Other Change to an Existing Approval Planning Act 2016

Application No:	MCU/12/0017
Street Address:	936 Tinaroo Creek Road, Mareeba
Real Property Description:	Lot 358 on OL451
Planning Scheme:	Mareeba Shire Council Planning Scheme 2016

936 Tinaroo Creek Road, Mareeba Request for 'Other Change' (MCU/12/0018)

936 Tinaroo Creek Road, Mareeba Request for 'Other Change' (MCU/12/0018) TRAFFIC IMPACT REVIEW

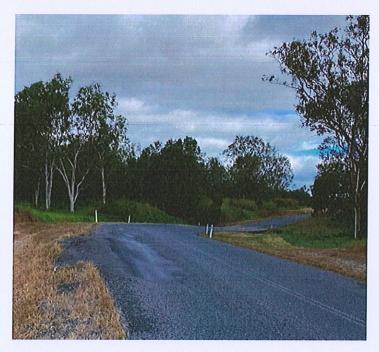
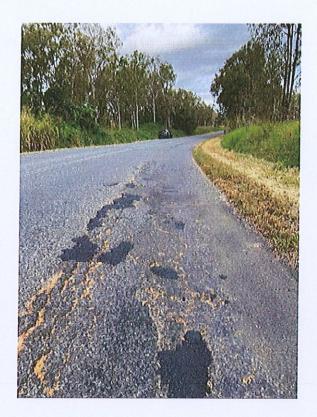
The photos show examples of key locations where sightlines were restricted due to tight bends and crests. As detailed in the report there are a number of locations which could benefit from an assessment of the geometry to ensure pavement width and warning signage is in accordance with relevant standards.

Included are also photos of some examples where there is evident pavement damage, primarily on the bends where heavy vehicles regularly turn. It is acknowledged that these defects are not solely attributed to the traffic generated by the concrete plant, however it is reasonable to assume that the unauthorised level of traffic associated with its operations could have had some level of contribution to the deterioration of the pavement at these locations.
